AXOD/AXODE (AX4S) UPDATE HANDBOOK

INTRODUCTION

This updated version of the AXOD "Update Handbook" will also cover the changes that occurred in the 1991 model year, when electronic controls were adapted to the AXOD transaxle, making it an AXODE, and now called an AX4S transaxle. We have included the changes on the AX4S transaxle up through and including model year 2002.

Figure 43

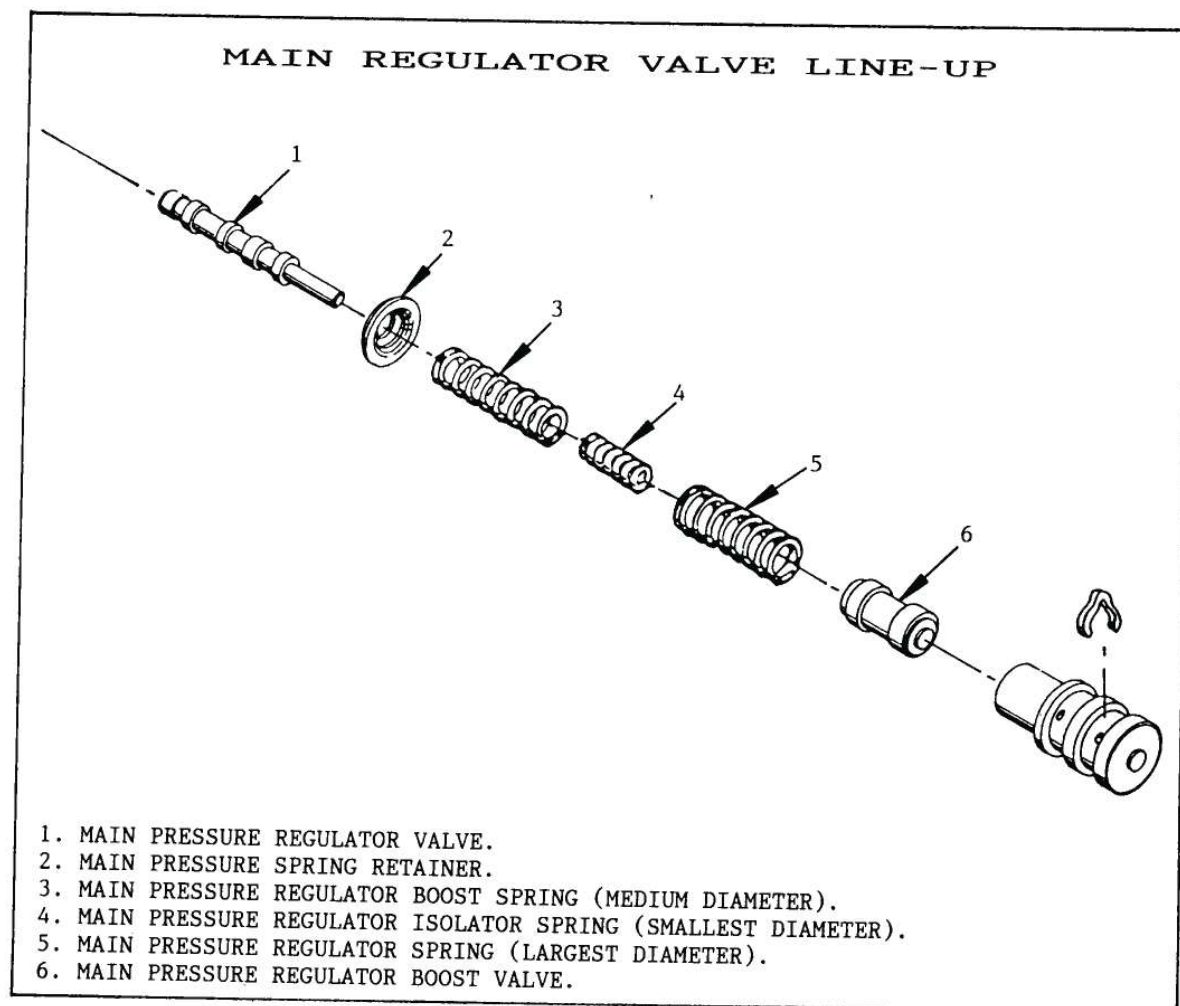
- NO. 2. Delayed upshifts after cleaning the valve body.
- CAUSE: NO. 1. A "Shudder" during a 1-2 upshift will occur if the main pressure regulator "Isolator" spring is not installed after cleaning the valve body (See Figure 43). This is caused by fluctuations in main line pressure at the time of the 1-2 shift.

- NO. 2. Delayed upshifts can be caused by the pressure regulator spring retainer being installed backwards (See Figure 43). This will create low main line pressure.

- CORRECTION: NO. 1. Insure that all three (3) pressure regulator springs are re-installed in the valve body regulator bore (See Figure 43).
1. Main Pressure Regulator Spring (Largest Diameter).

2. Main Regulator Boost Spring (Medium Diameter).
 3. Main Regulator Isolator Spring (Smallest Diameter).
- NO. 2. Insure that the main regulator spring retainer is installed in the proper direction (See Figure 43). The retainer is very similar to the one used in the AOD valve body, but is installed in the opposite direction of the AOD (See Figure 43).

Figure 44

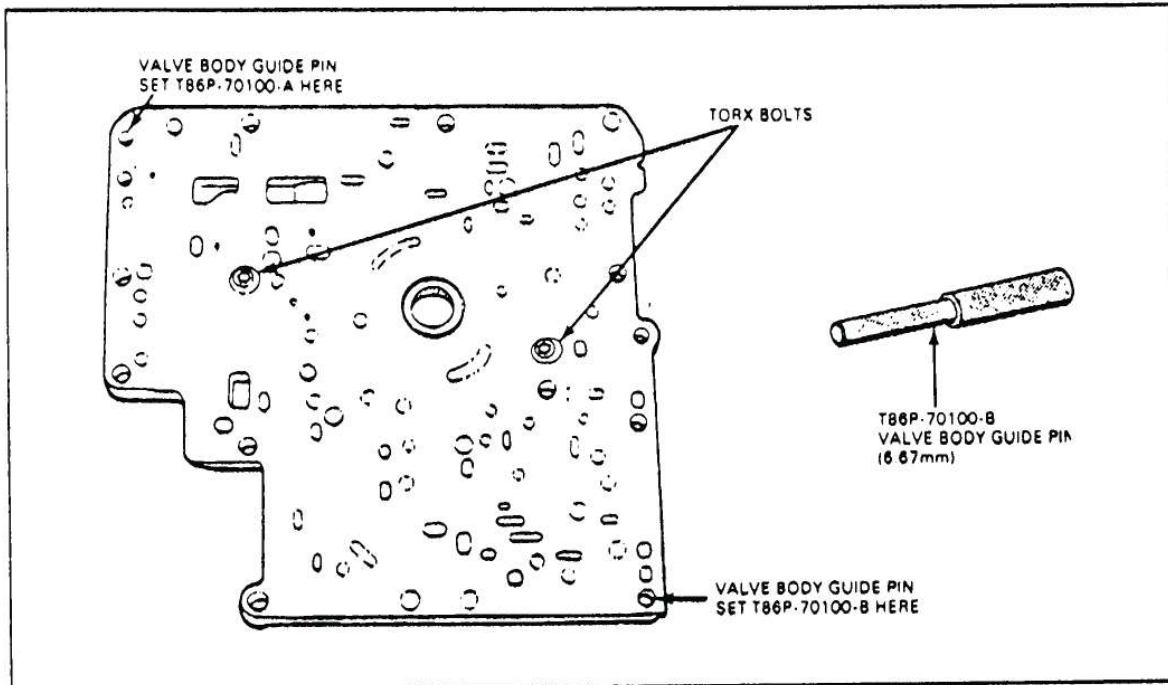
1. Position the spacer plate on the pump housing, using a new gasket.
2. Insert valve body guide pin T86P-70100-A (.271" Diameter) and valve body guide pin T86P-70100-B (.262" Diameter), as shown in Figure 44.
3. Install two "Torx" bolts and torque to 7 to 9 ft.lb.
4. Remove both guide pins.
5. Position the spacer plate on the valve body using a new gasket.
6. Insert two valve body guide pins T86P-70100-A (.271" Diameter, as shown in Figure 45.
7. Install two "Torx" bolts and torque to 7 to 9 ft.lb.
8. Position the oil pump on the valve body using a new gasket.
9. Insert pump body guide pin T86P-70370-A and valve body guide pin T86P-70100-C which is .245" in Diameter.
10. Install two valve body to oil pump retaining bolts and torque to 7 to 9 ft.lb.

Figure 48

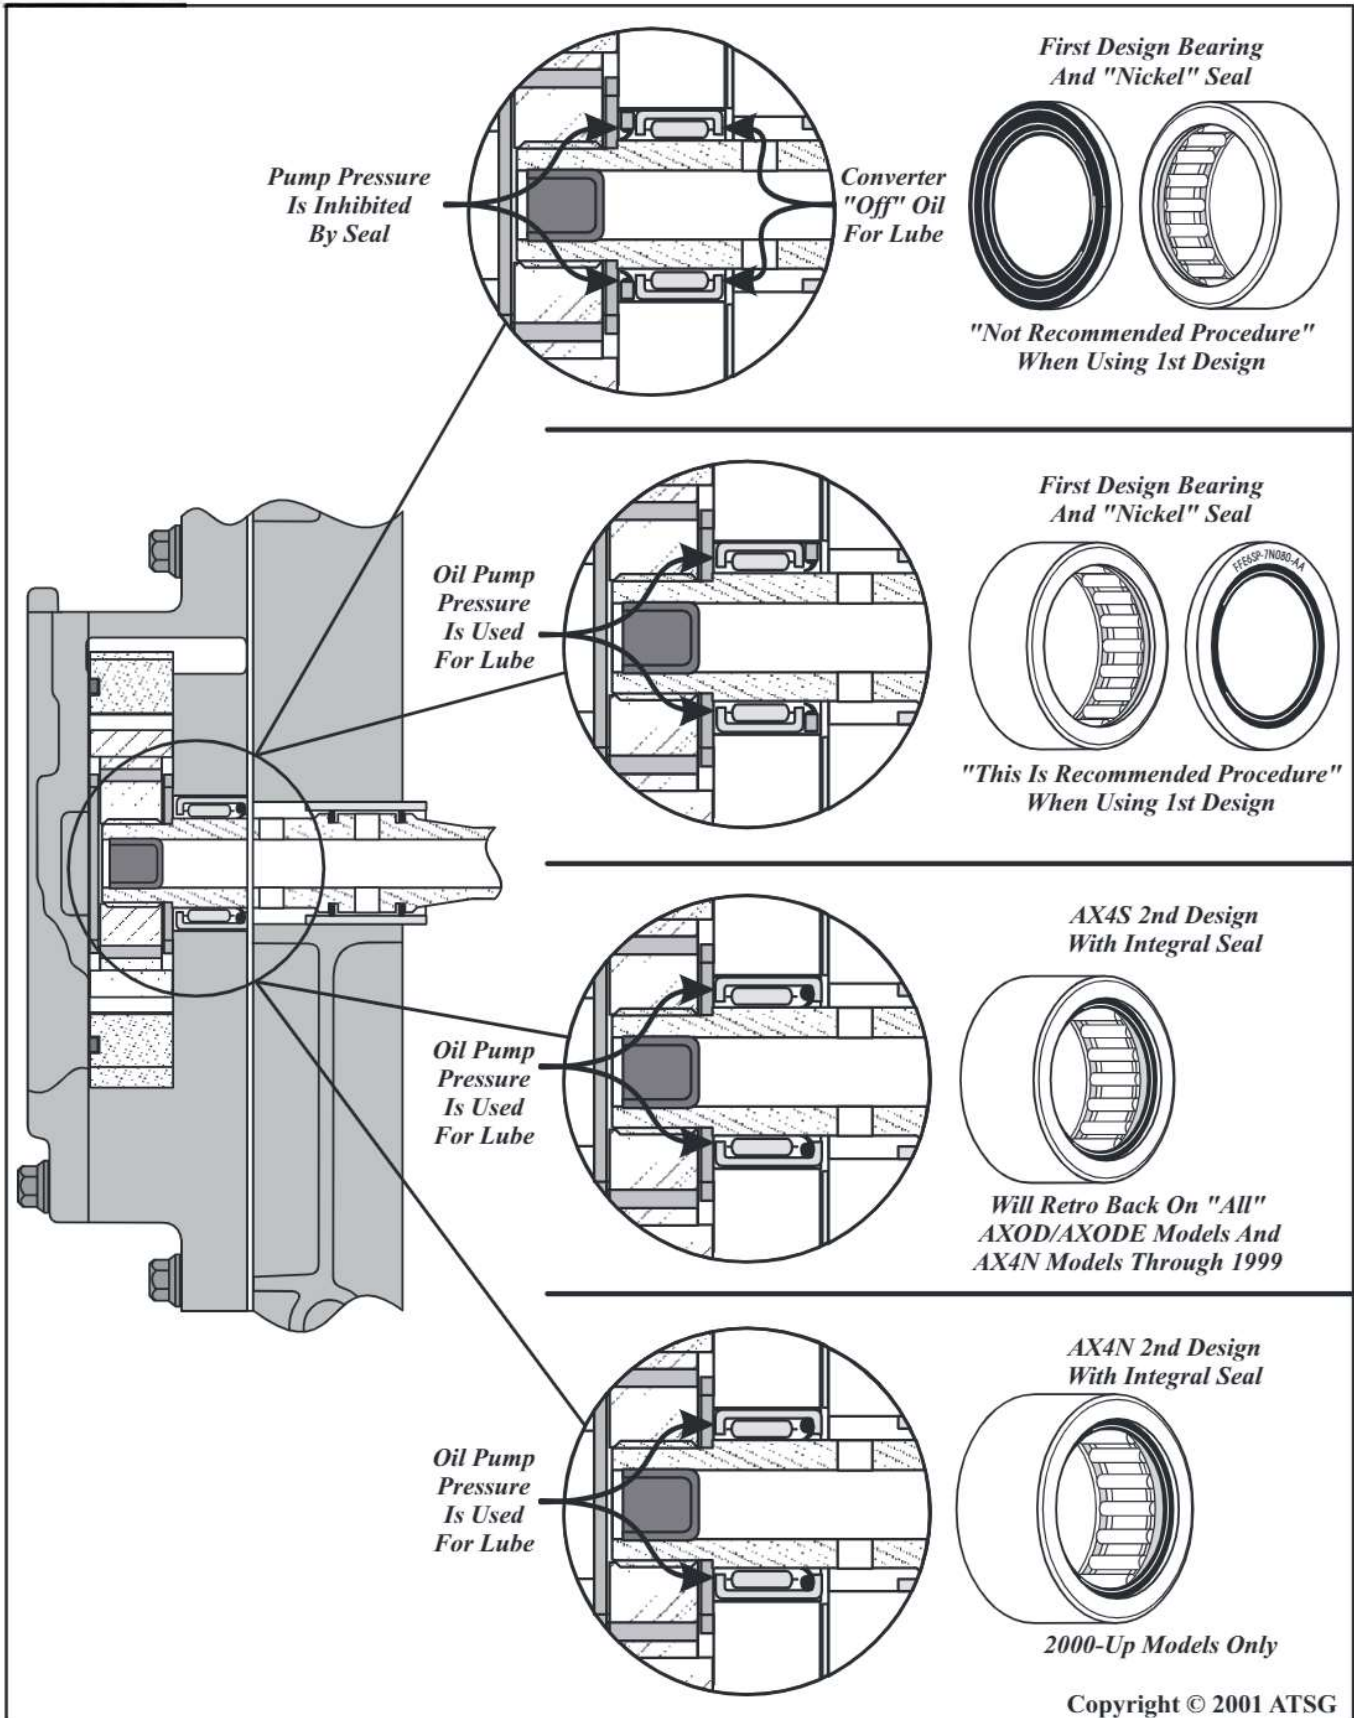
AXOD/AXODE (AX4S) - When using the 1st Design bearing with the "Nickel" Seal, install the seal on the valve body side, with the part number facing up, as shown in Figure 48.

Figure 55

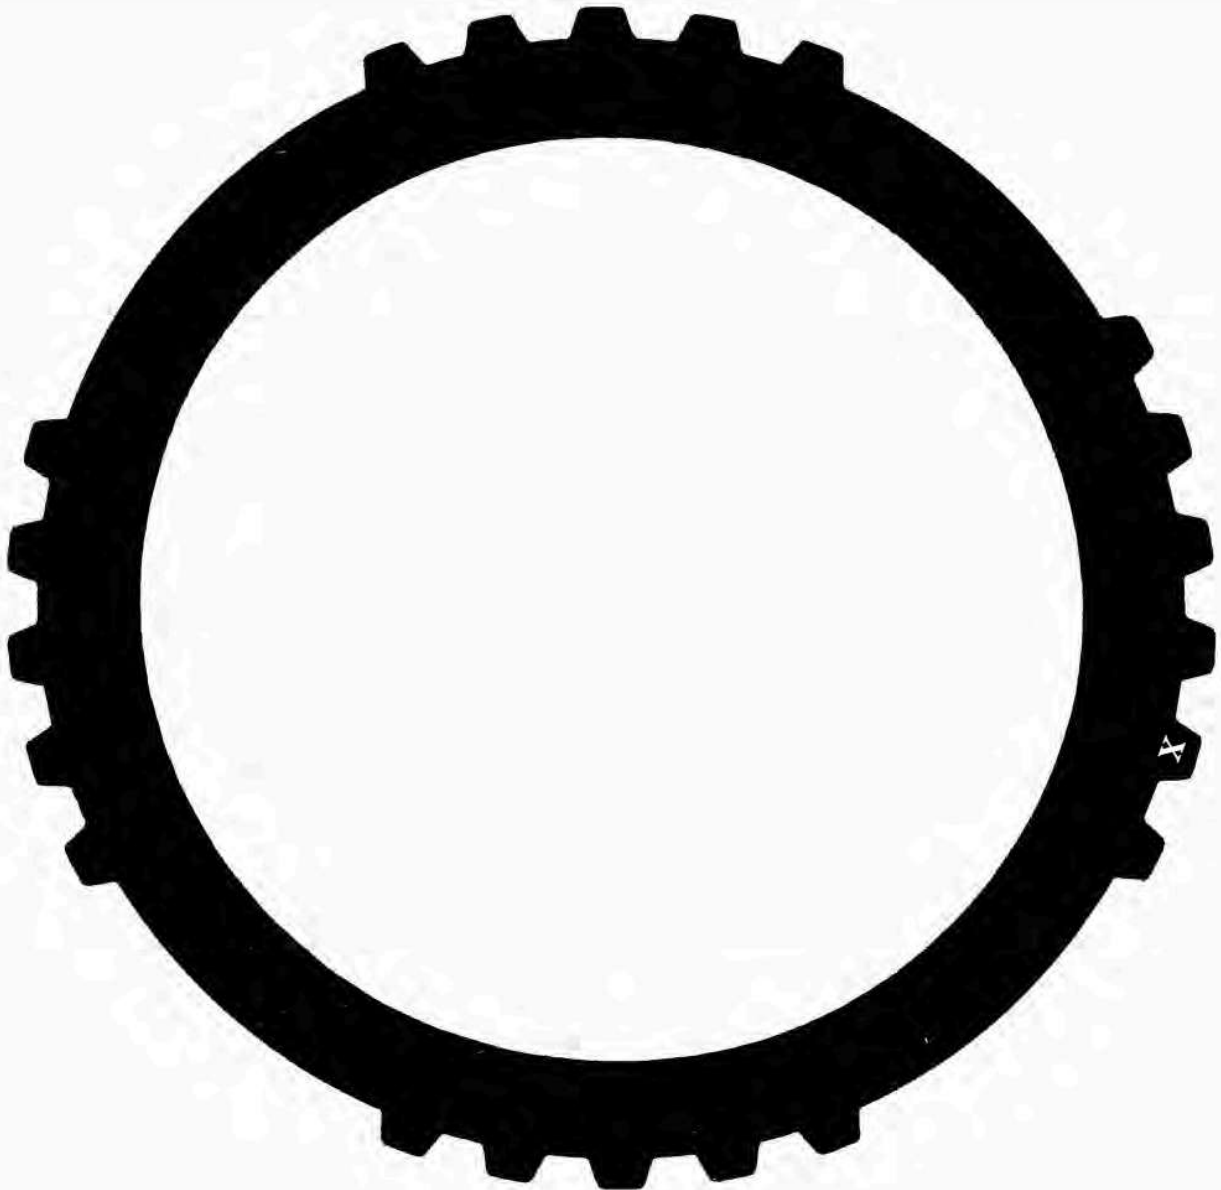
2ND DESIGN - Has 21 external teeth, inside diameter of 4.730", material thickness of .075", identified with letter "X" stamped on 1 tooth, and was used from 1989-1991. (See Figure 55).

Figure 56

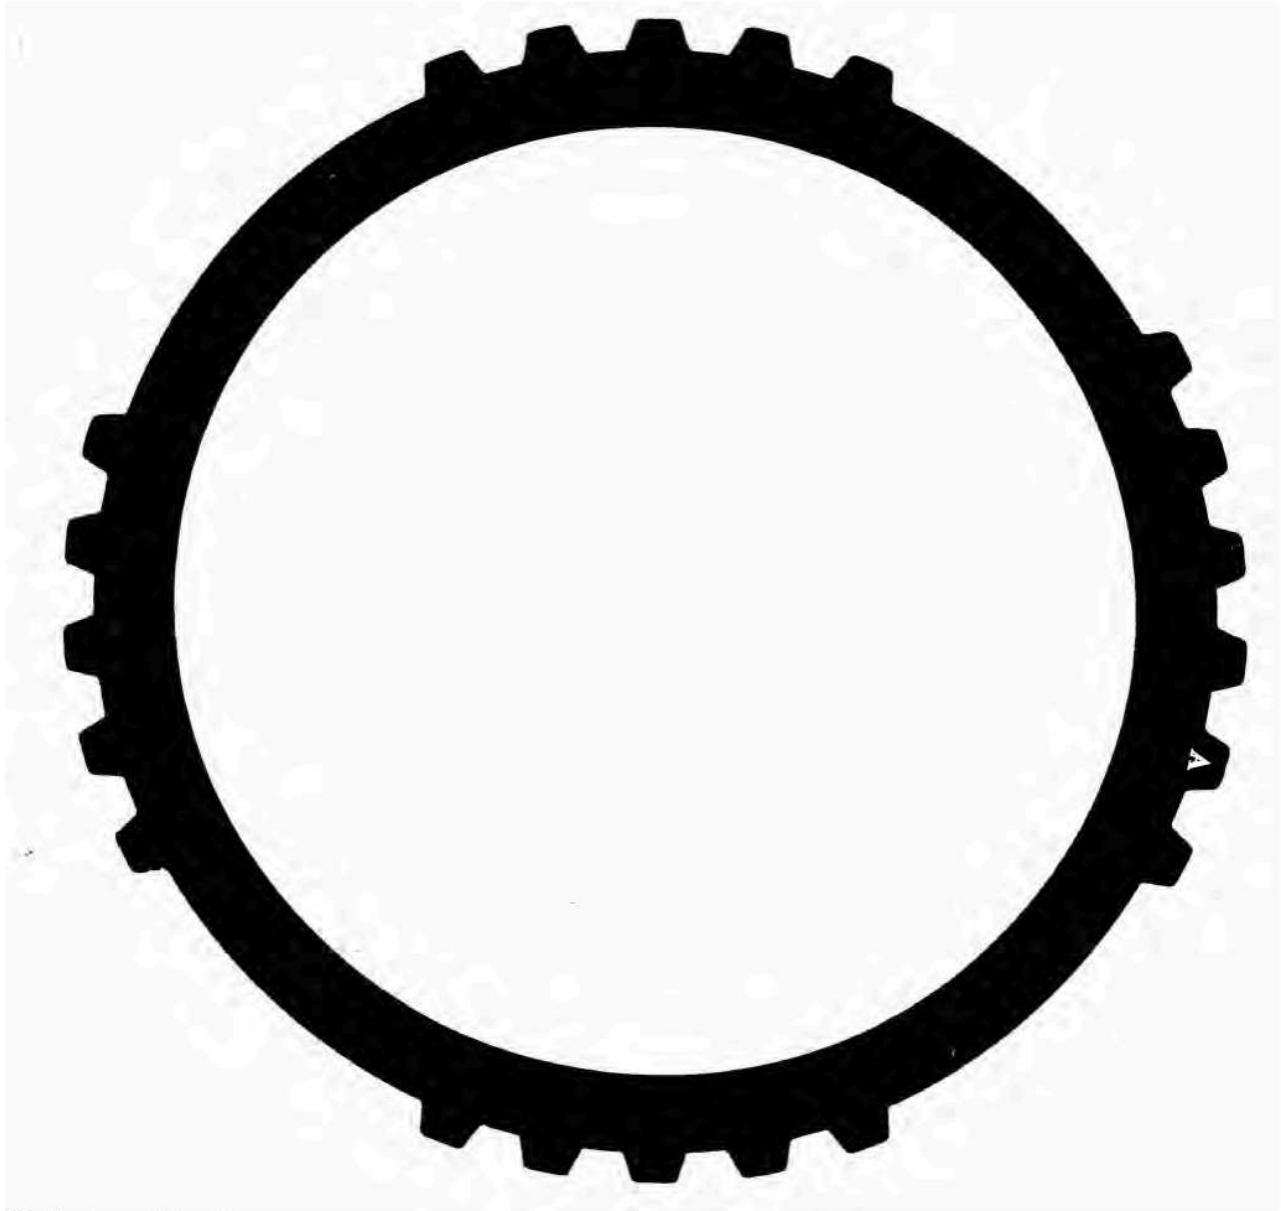
3RD DESIGN - Has 21 external teeth, inside diameter of 4.930", material thickness of .083", identified with letter "A" stamped on 1 tooth, used in 1992 and later models. (See Figure 56).

The 3rd design forward clutch wave plate was associated with a change in the entire forward clutch pack and should be used **Only** with the later design forward clutch pack, which are a larger inside diameter.

Figure 57

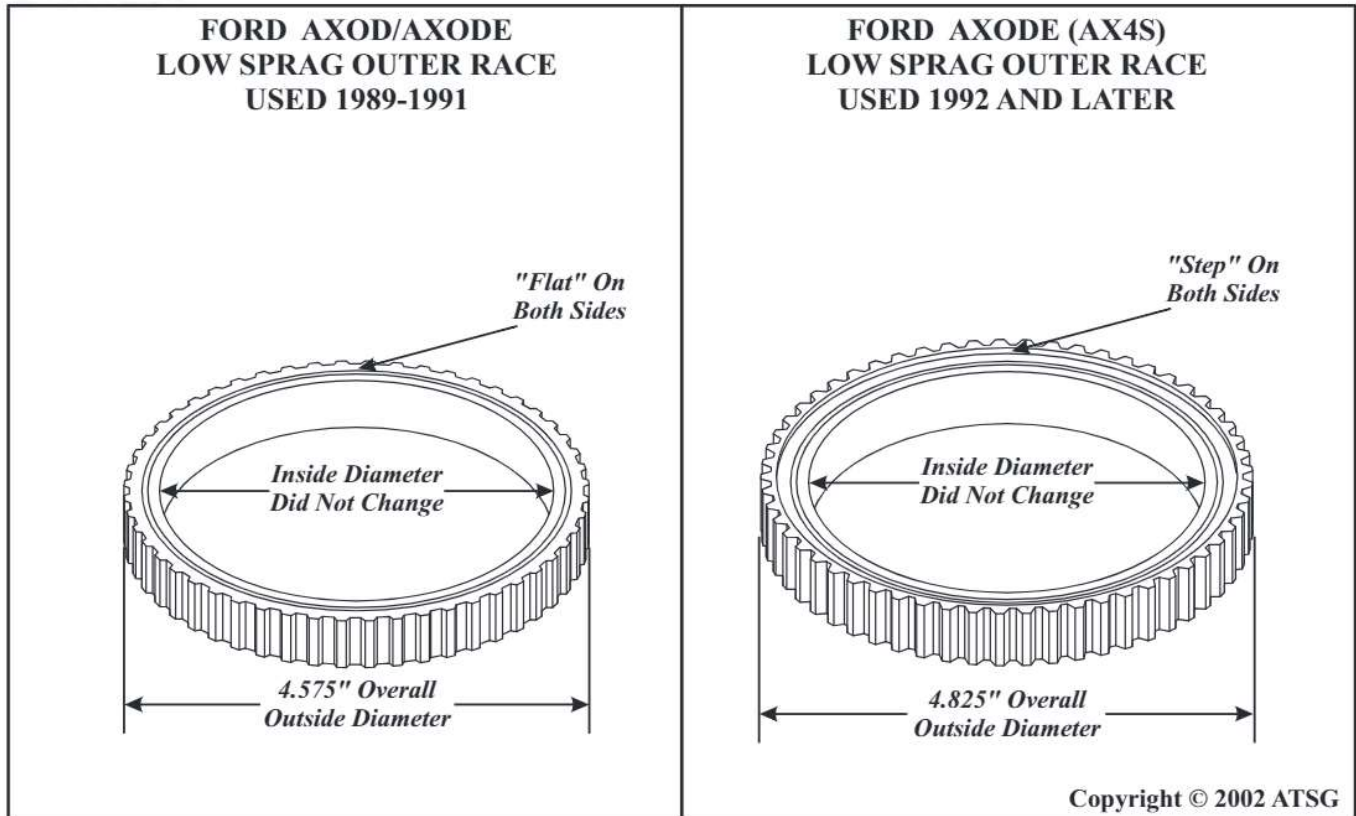
- (1) LOW SPRAG OUTER RACE - The outer diameter of the race was increased from 4.575" to 4.825", and the width of the race was increased from .600" to .725", as shown in Figure 57. ***The Inside Diameter of the sprag race Did Not Change.***

Figure 58

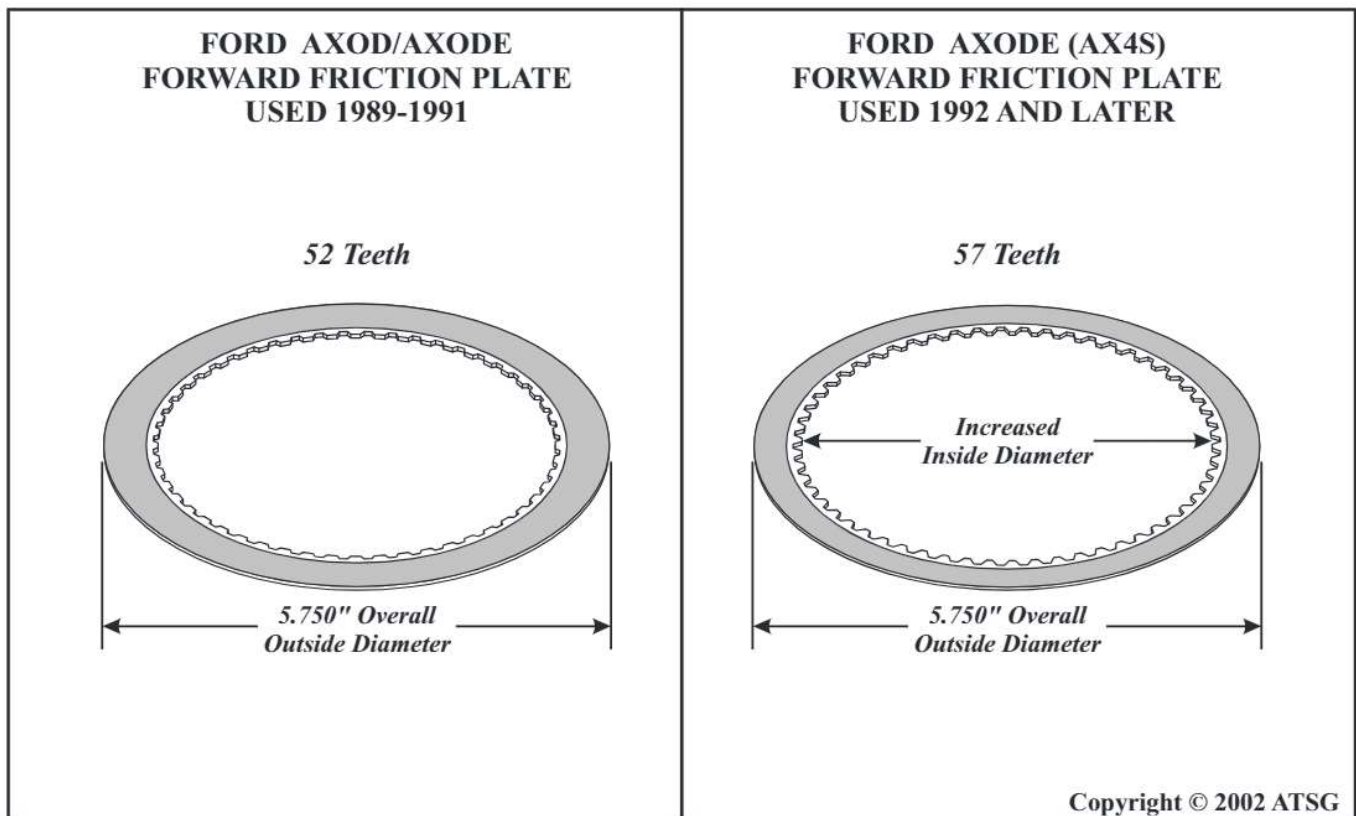
- (2) FORWARD CLUTCH FRICTION PLATES - Have an increased amount of teeth to 57 Teeth from the previous 52 Teeth, to accommodate the increased diameter of the sprag outer race, as shown in Figure 58.

Figure 59

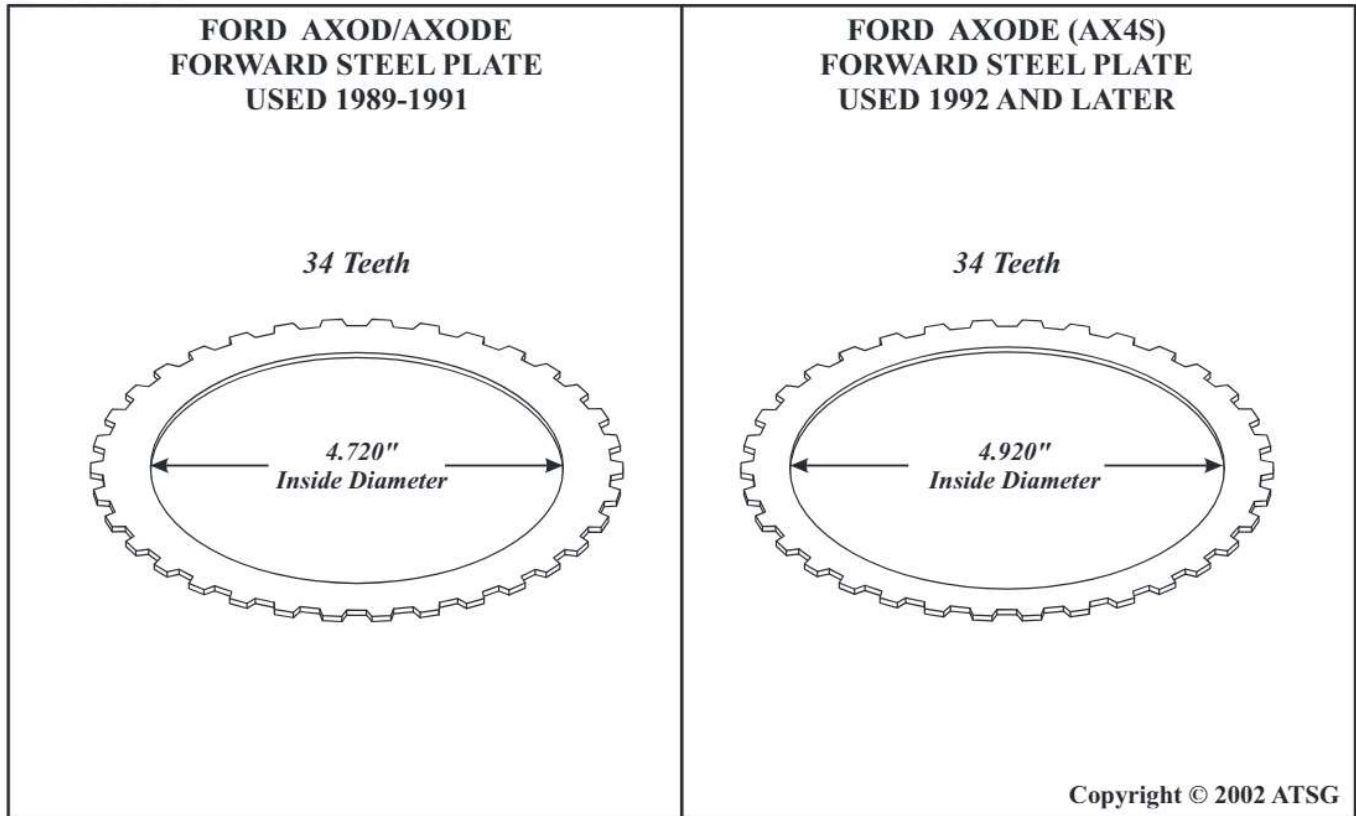
- (3) FORWARD CLUTCH STEEL PLATES - Have an increased inside diameter to 4.920" from the previous 4.720", to accommodate the increased diameter of the sprag outer race, as shown in Figure 59.
